IEEE P802.3bt PSE State Diagram Update

Dan Dove, DNS for LTC

June 15, 2015

Type 3 and Type 4 PSE Searching (SRCH) State Diagram

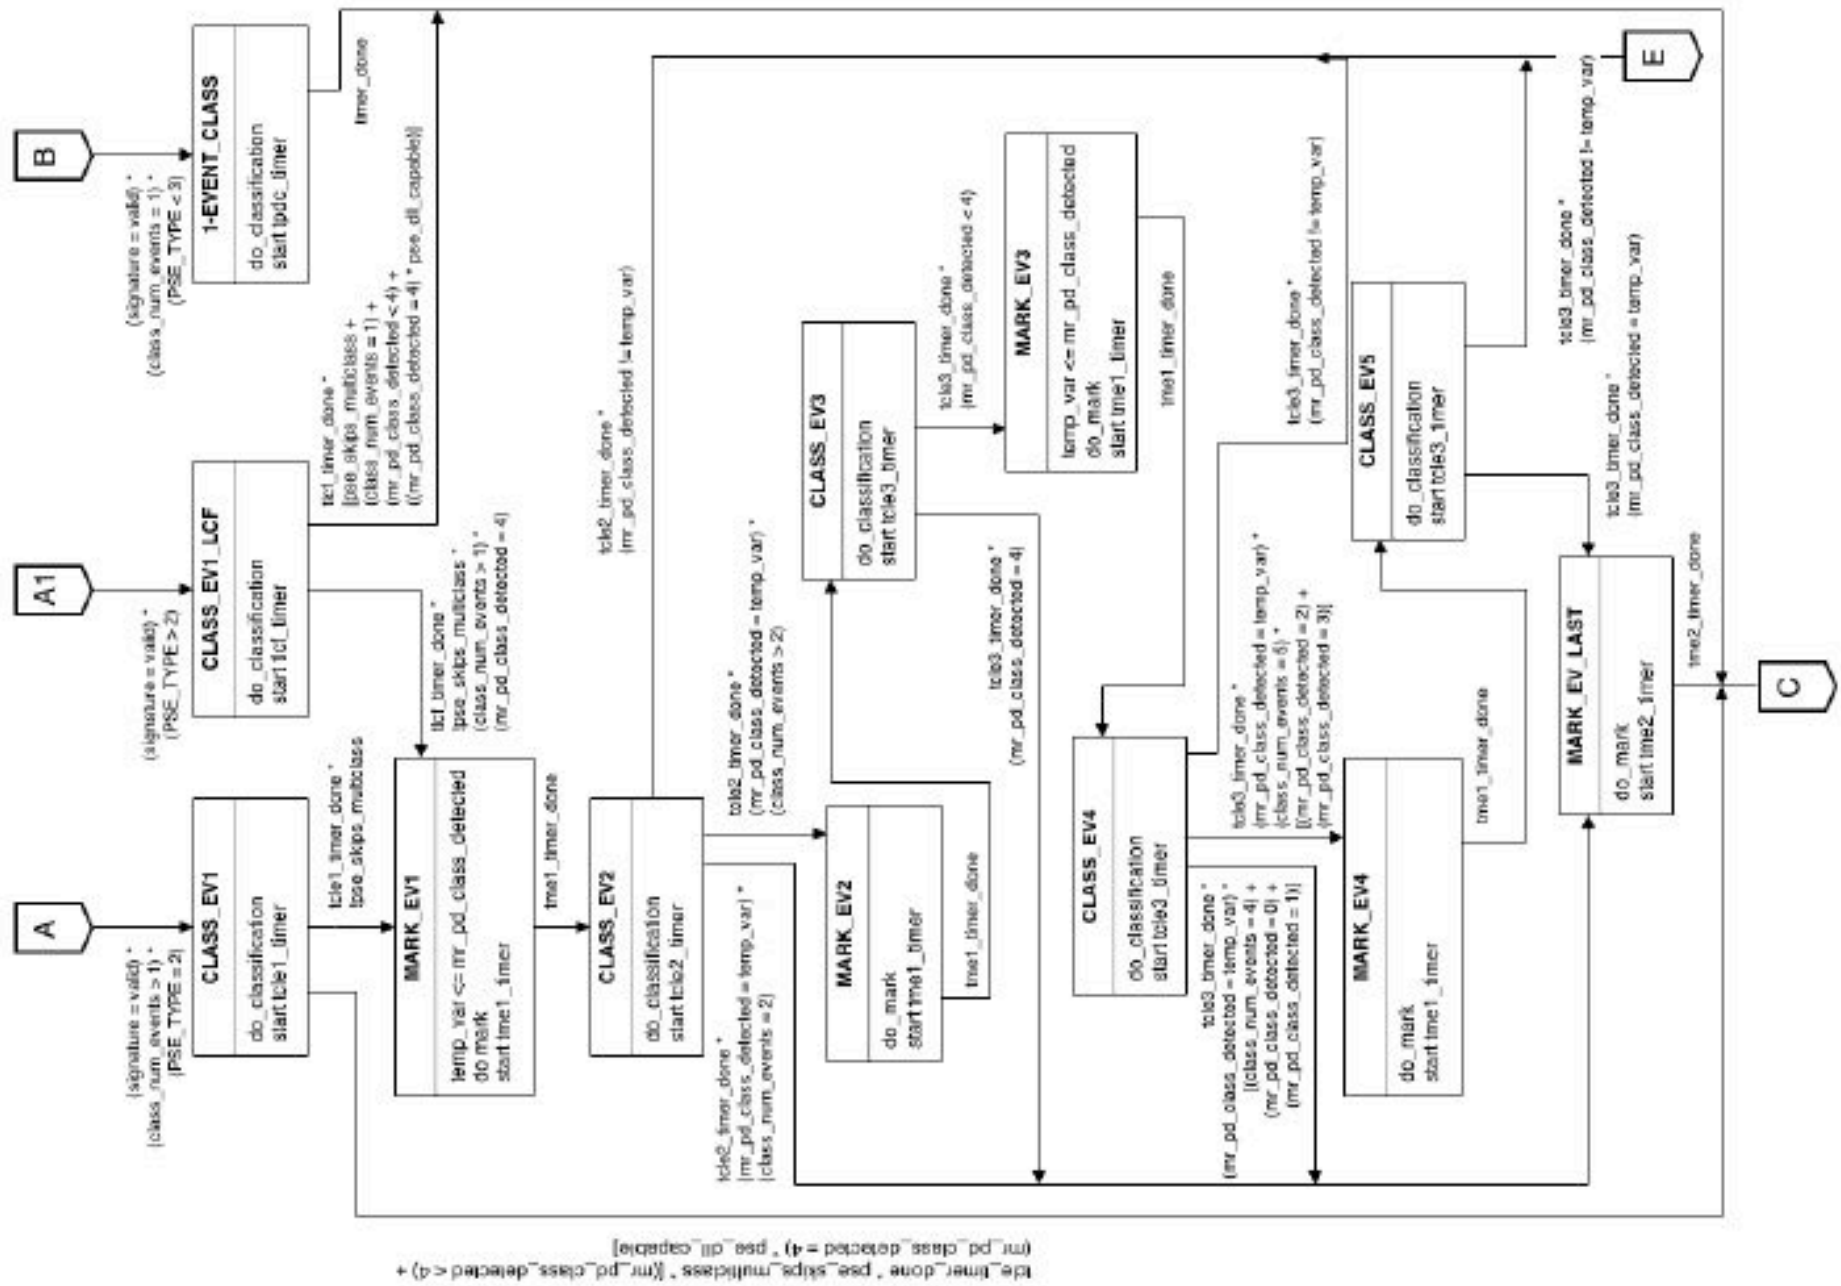
Detection and Connection Check carry a lot of redundancy:

- Both have Invalid and Open Circuit results.
- Both seek to determine whether a valid PD is present
- Neither tells you which ALT the signature is present on.

Proposal – Eliminate Connection Check and Enhance Detection

Rationale for removing Connection Check, enhancing Detection:

- Both have Invalid and Open Circuit results.
- We only need to clearly articulate the conditions such that correct interpretation of the results can be achieved.
- Both seek to determine whether a valid PD is requesting power.
- One seeks to find if a PD is requesting power, the other seeks to determine if that PD is requesting power on one alternative, or both.

Proposal provides all necessary information in a single function

AF,AT and single-channel PSEs will receive necessary information to apply power. Type 3 and Type 4 dual-channel PSEs will receive necessary information to apply power to either pair set or both pair sets.

Type 3 and Type 4 PSE Classification State Diagram

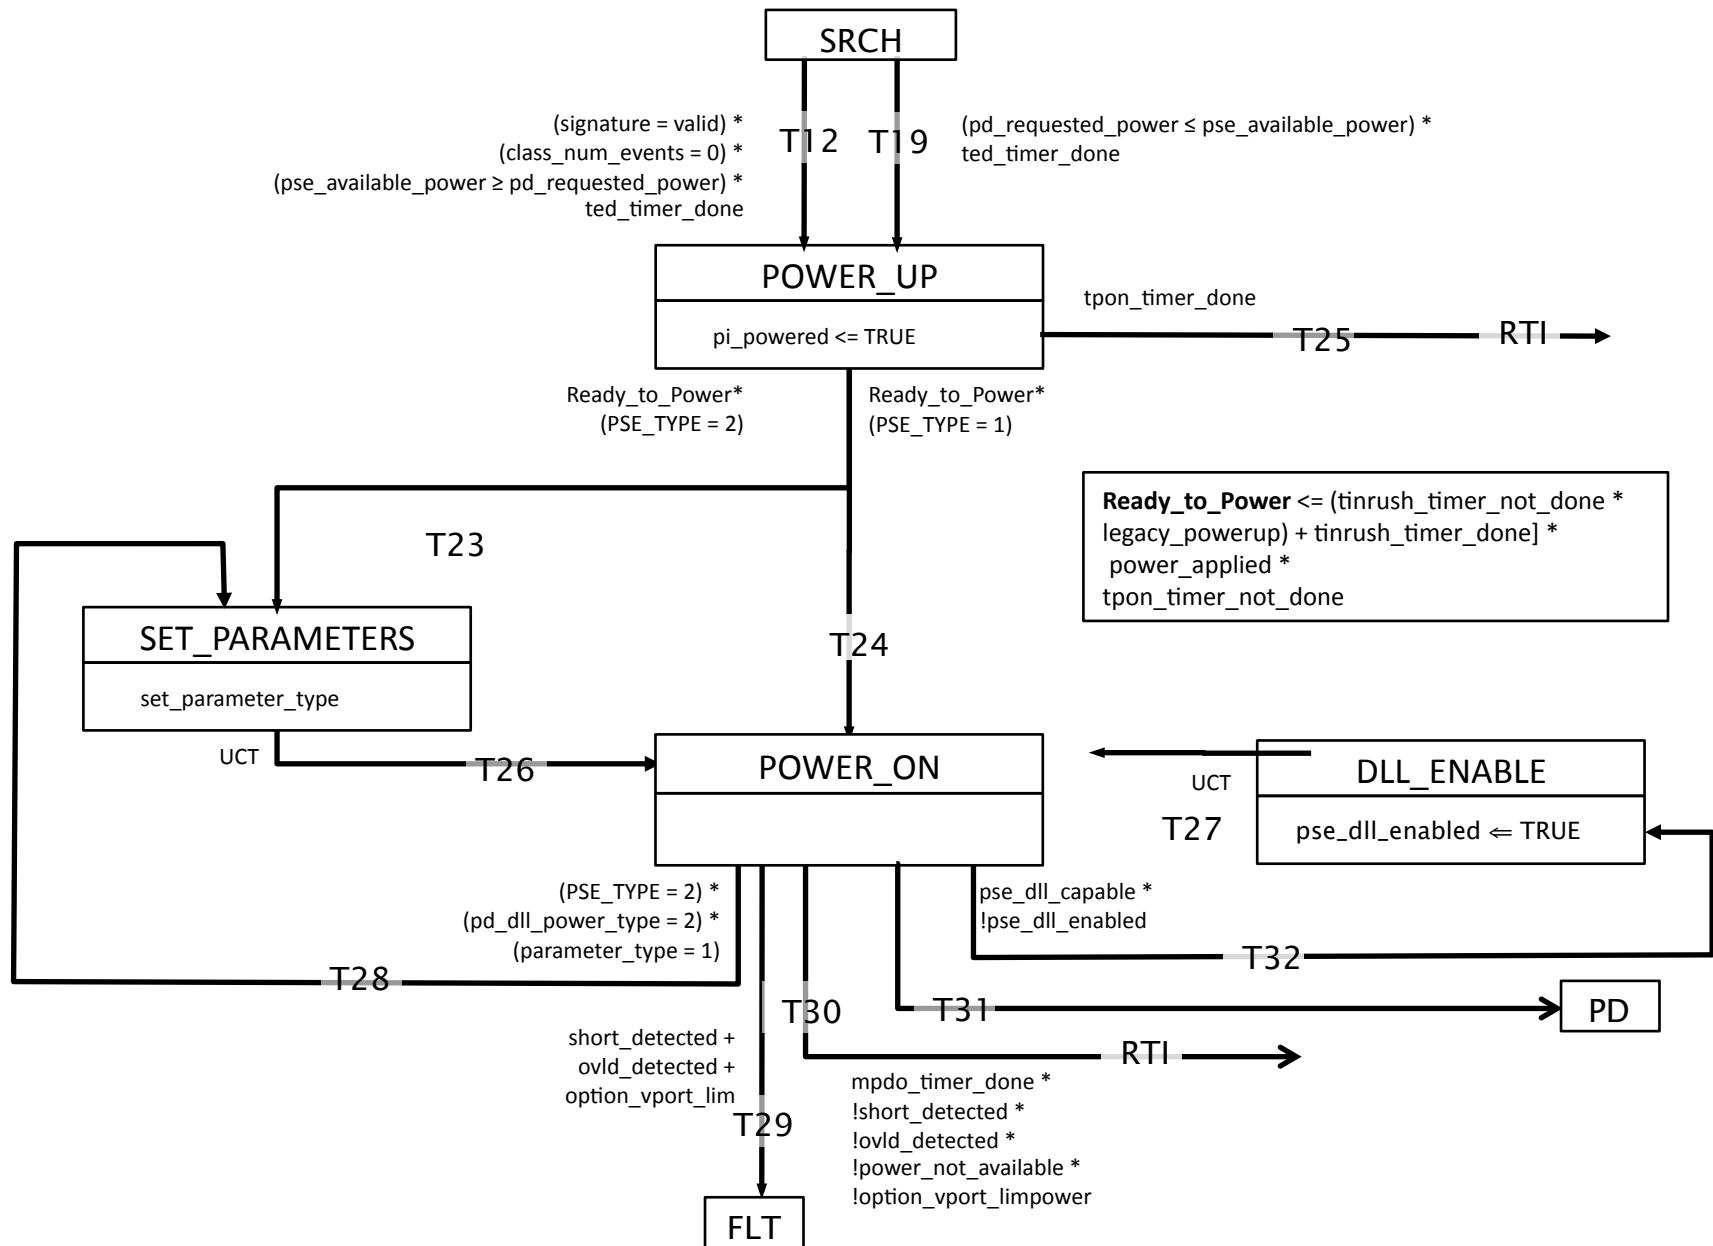
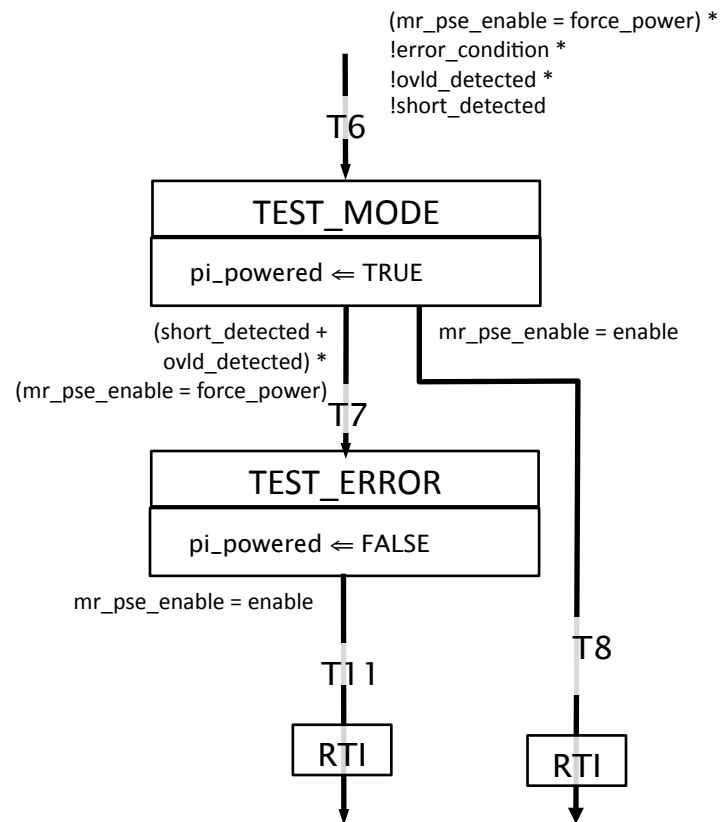
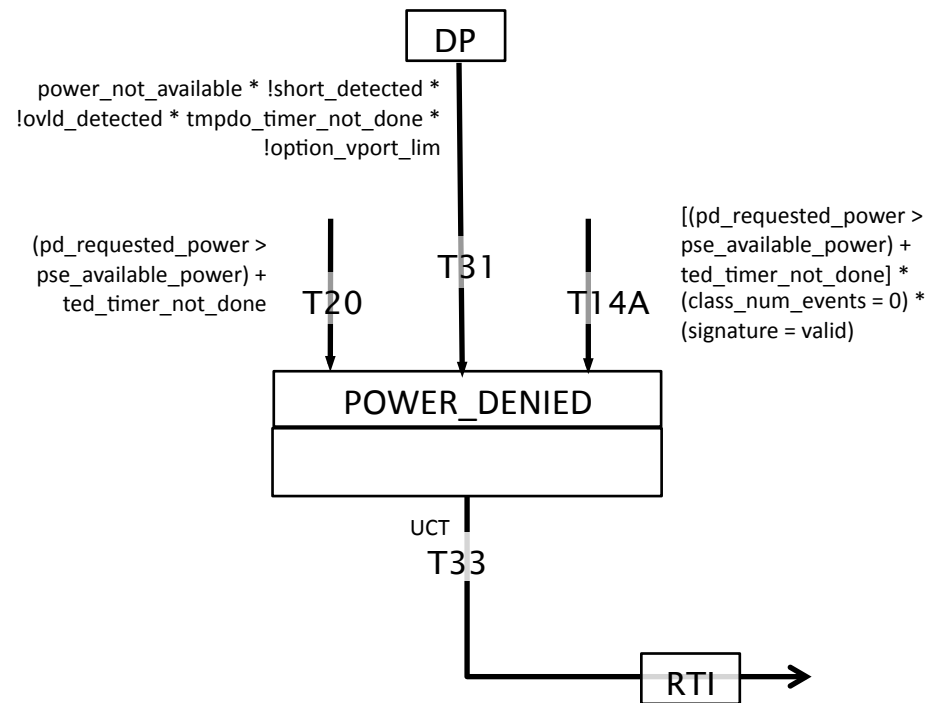
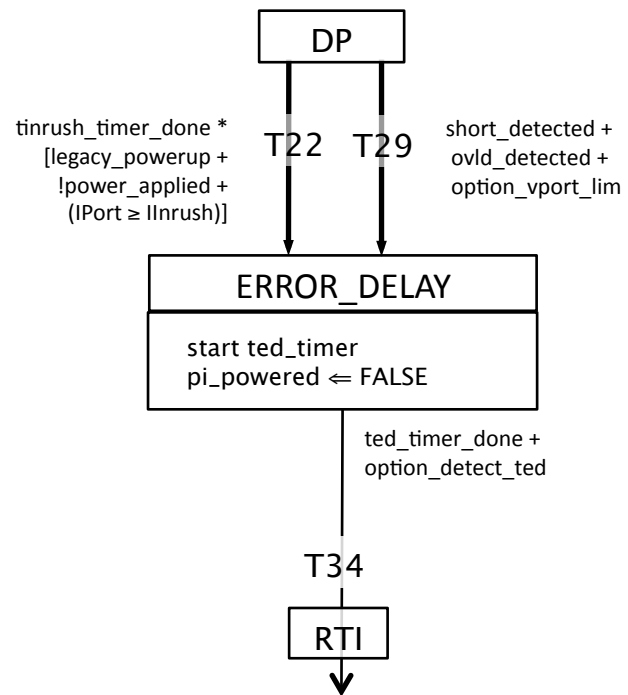
Issues with the Classification State Diagram:

- Doesn't address how a dual channel PSE classifies each pair set
 1. One entry point into Classification State Diagram
 2. No method shown to classify alt-A versus alt-B

3. This assumes only one classification per PD, and does not provide guidance on which pair set to perform classification.
 - a. We can assume that classification can be done on either pair-set and only do it once and it will total power required by the PD for cases of dual-channel and single-channel PSEs.

- b. We can assume that classification for single signature PDs equals total total PD power and that classification for dual signature PDs must equal half of total PD power on each pair set.

4. OR we must perform classification on both pair sets (for dual-signature PDs) and determine the power for each pair set independently from the other.

- I recommend 3a
- I cannot advise on changes to the PSE and/or Classification State Diagram wrt Classification until these concerns are answered.
